PD Modification Application: PRS 21-1039

BOCC Land Use Meeting Date: October 12, 2021

The applicant requests a minor modification to PD 18-0404 to allow an increase in height (both development options) and for access (primary and cross access) relocations. This PD is approved for two development options – Option 1 for CI zoning district uses with a maximum F.A.R. of 0.75 (90,017 sf); or Option 2 for for a mixed use project consisting of hotel, retail and/or office uses utilizing the mixed use density bonus of the Comprehensive Plan to allow a maximum F.A.R. of 1.0 (120,022 sf). Option 2 is approved for a higher maximum building height to accommodate the approved square footage.

8.2 Proposed Site Plan (Full) Sheet 1 of 3

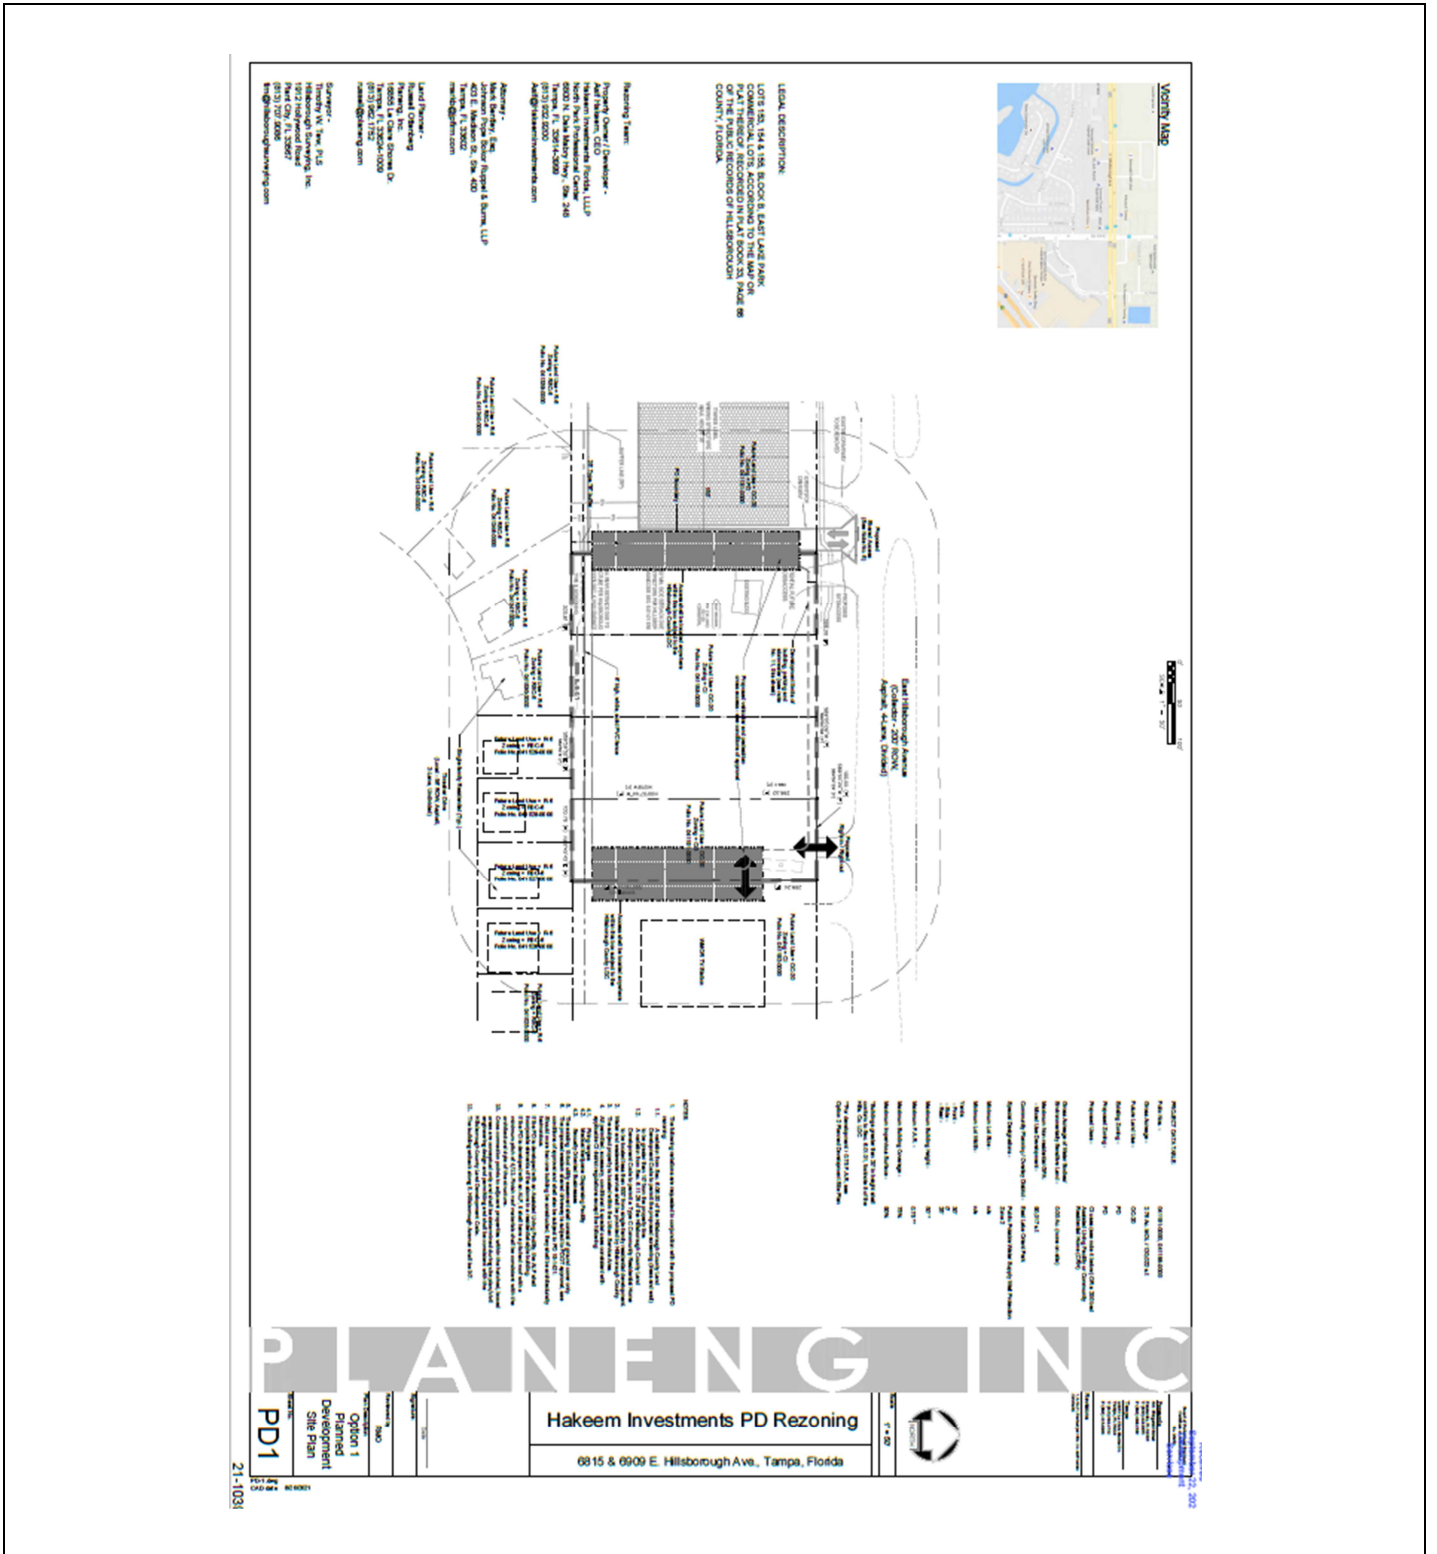
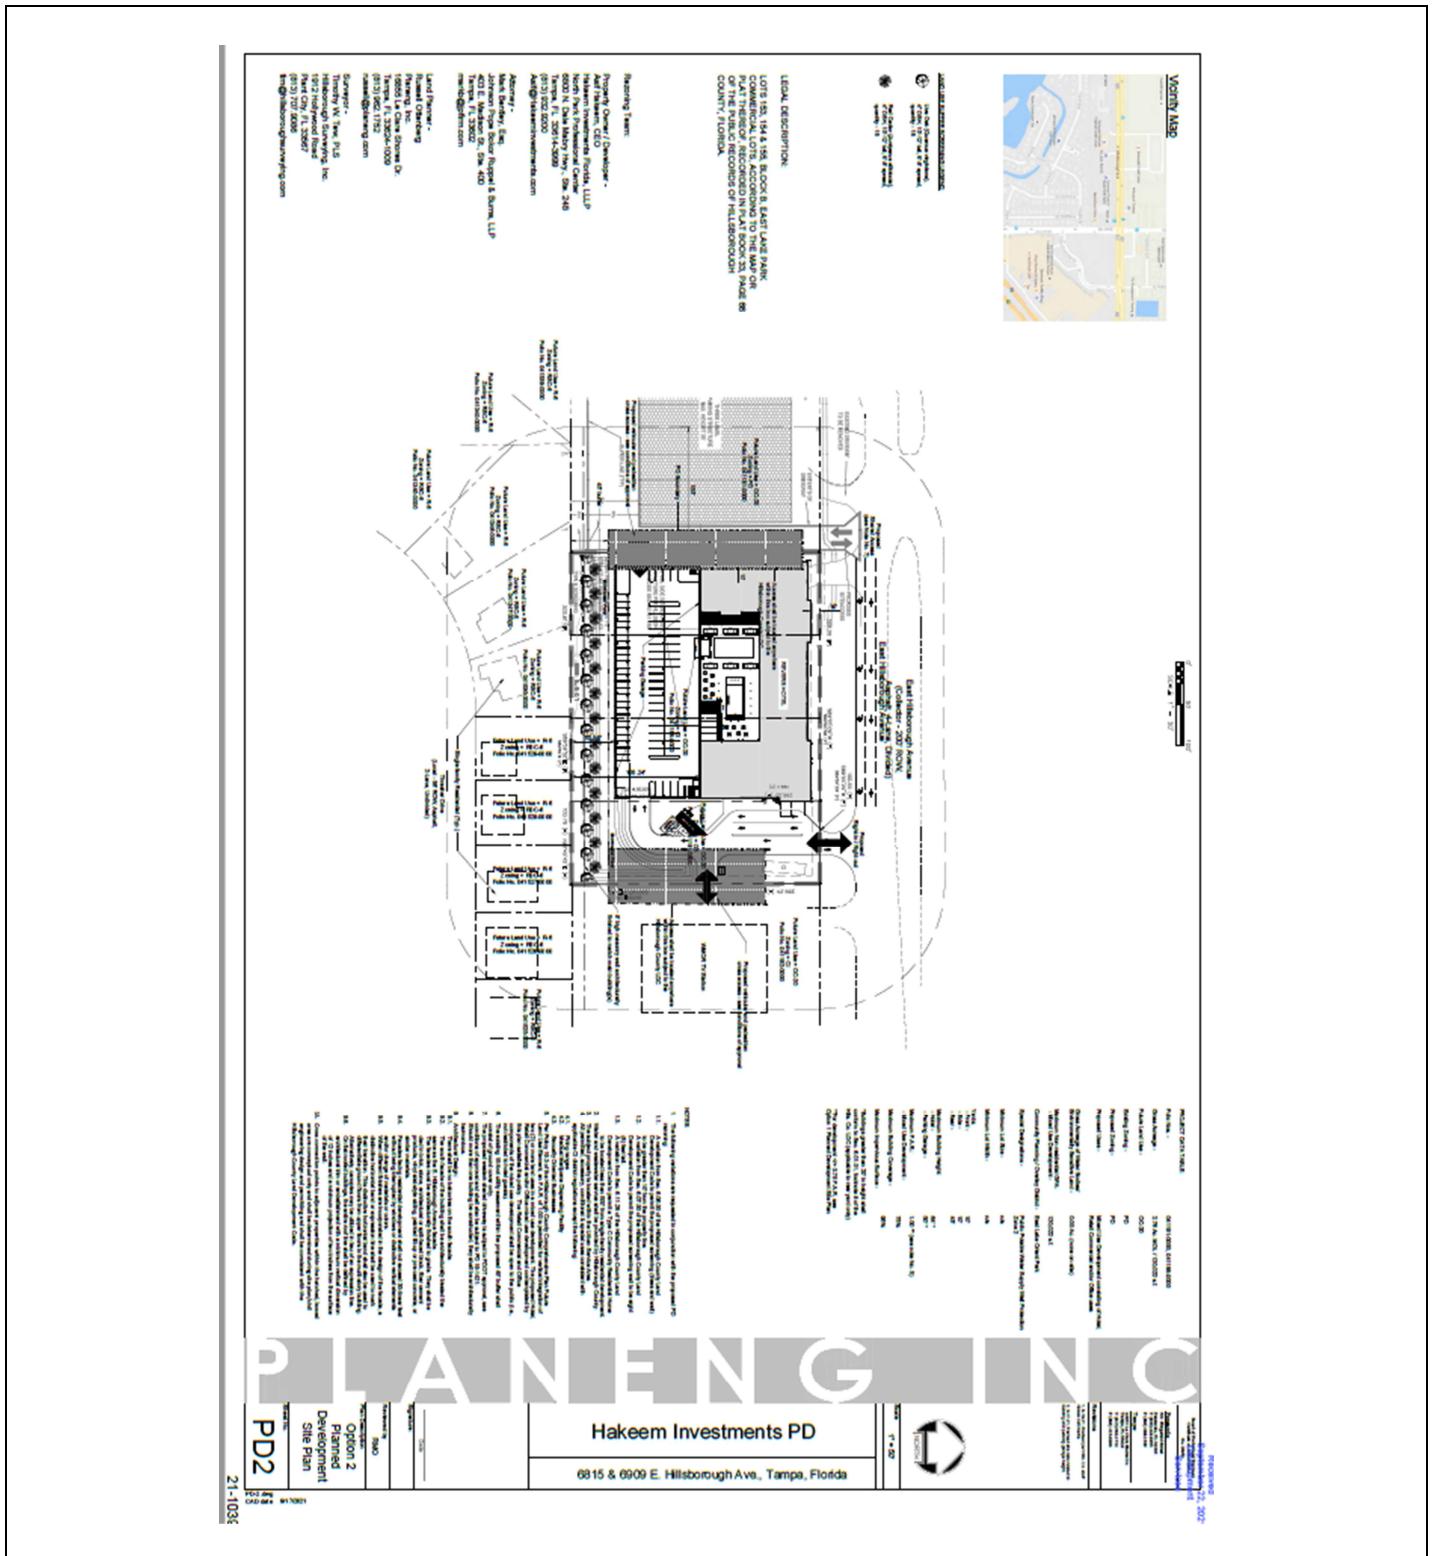
The proposed modification will eliminate the western access connection on E. Hillsborough Ave. on both development options 1 and 2; and shift the location of the western shared access facility south of the current location and shifts the location of the cross access slightly to the south on development option 2.

To allow for greater flexibility for the developer to coordinate the shared access and cross access points with the adjacent property owners to the east and west, access bonding boxes have been added to the proposed site plan wherein the exact locations maybe established a future date consistent with the LDC, Part 6.04.00 standards.

7. The applicant shall provide a pedestrian and vehicular cross-access stubout to the adjacent eastern property (Folio#41192.0000) anywhere within the bounding box depicted in the site plan consistent with the LDC.

10. ~~If a second access connection is not constructed, the~~ The applicant shall provide a pedestrian and vehicular cross-access stubout to the western property (Folio# 41181.0000): anywhere within the bounding box depicted in the site plan consistent with the LDC.

8.2 Proposed Site Plan (Full) Sheet 3 of 3

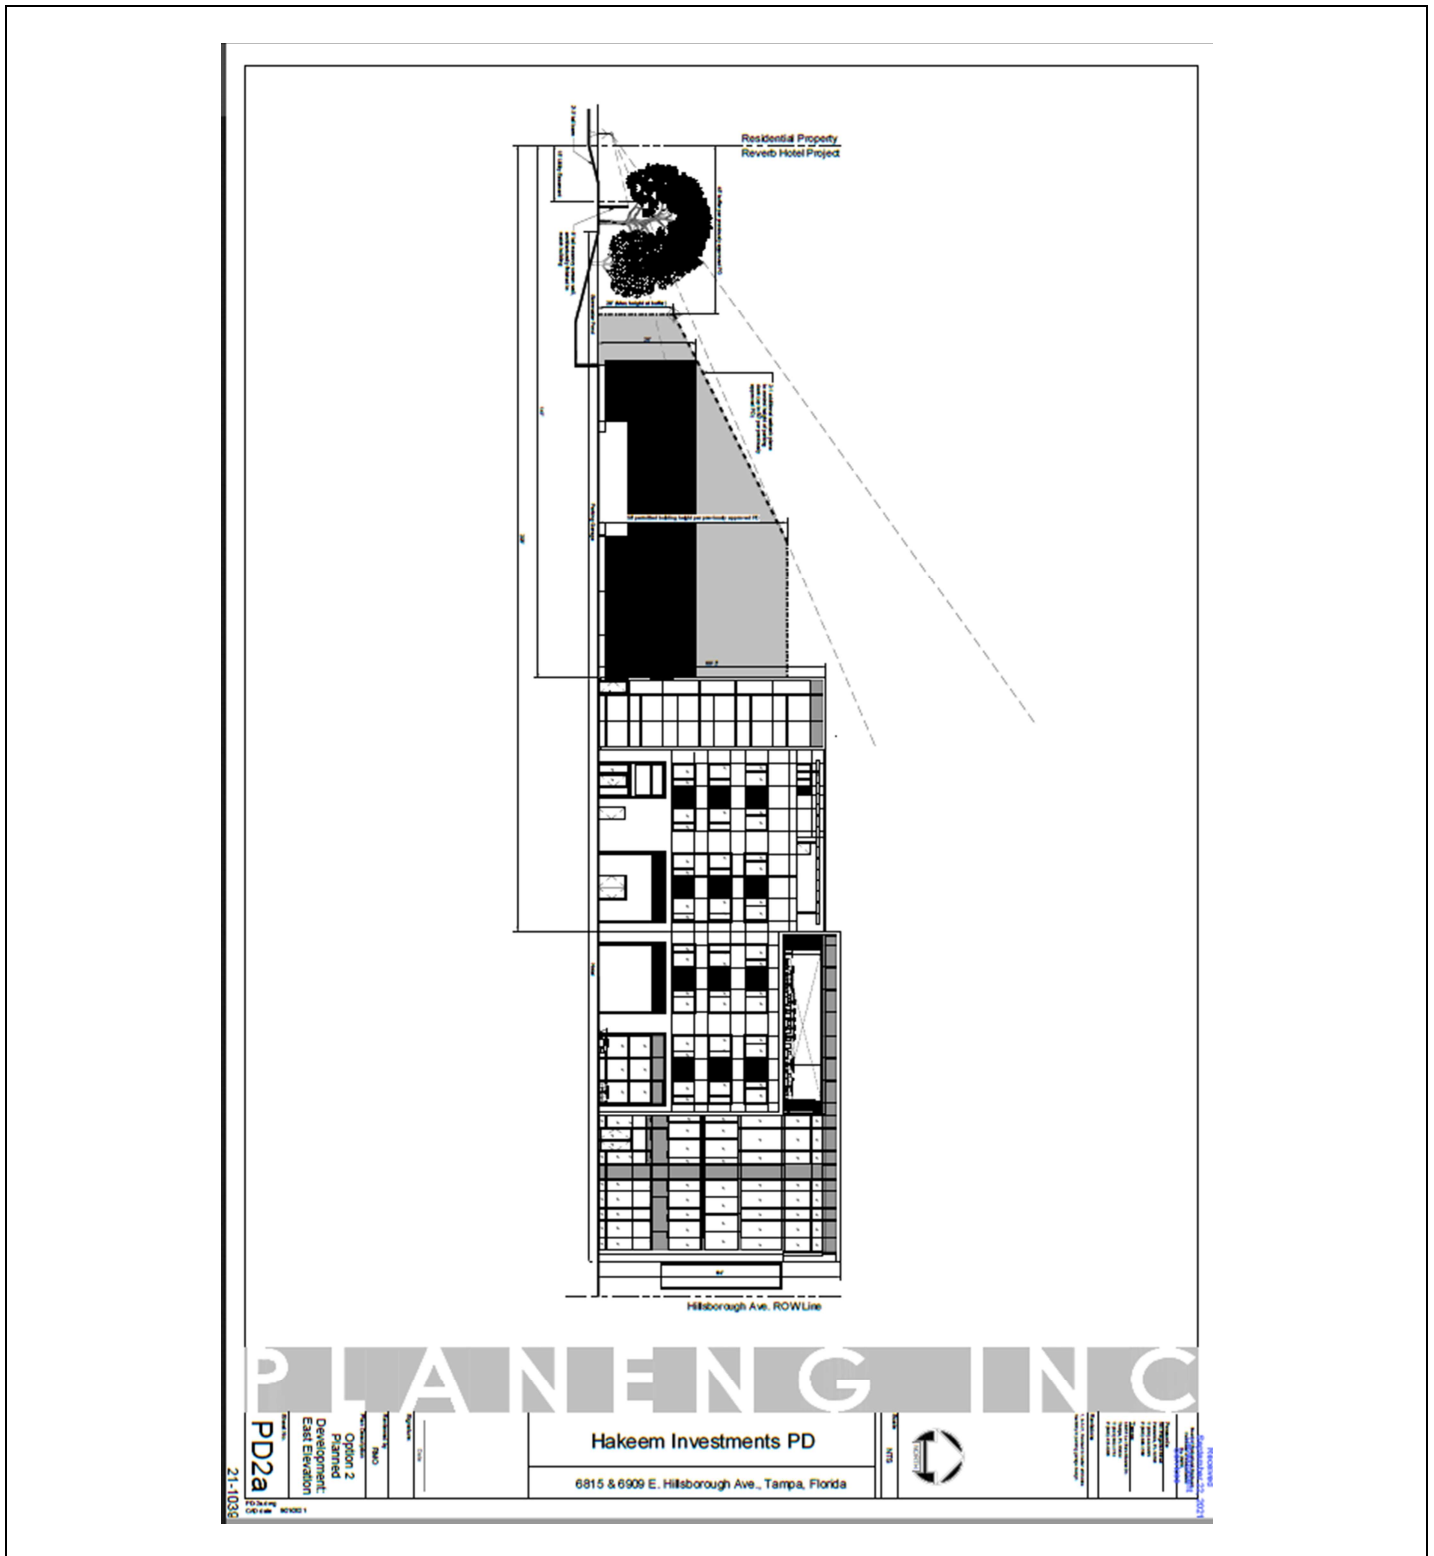
This possible height increase is due to a standard building design for the Reverb Hotel brand, as illustrated on Sheet 3 of the proposed general site plan. This proposed 64' building height exceeds a 2:1 building setback by 75 feet. The structure closest to the rear of the site (the parking garage) will be constructed using screen panels to reduce the visibility of cars. The minimum setback meets the 2:1 setback for the 26' building height and additionally screening, as originally conditioned, will be provided.

*At a height of 61 feet, non-parking garage buildings shall be a minimum of 141 feet from the southern PD boundary. At the maximum height of 64 feet, non-parking garage buildings shall be a minimum of 208 feet from the southern PD boundary. Alternatively, should the non-parking garage building(s) be less than or equal to 50 feet in height, the non-parking garage buildings shall comply with an additional setback of 2 feet for every 1 foot over 20 feet in height as measured from the rear yard setback of 45 feet.

REQUEST: Proposed Bldg height increase

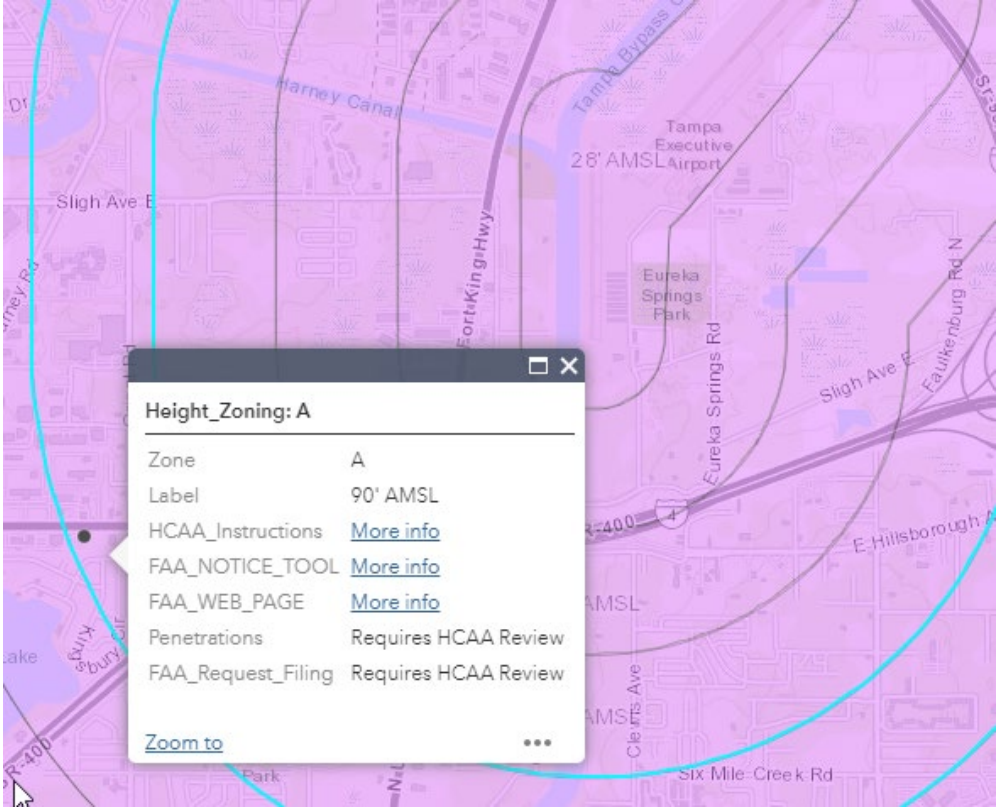
The proposed site falls within Zone "A" on the Airport Height Zoning Map. Any structure including construction equipment that exceeds 90 feet Above Mean Sea Level will require an Airport Height Zoning Permit and must be reviewed by the Airport Zoning Director.
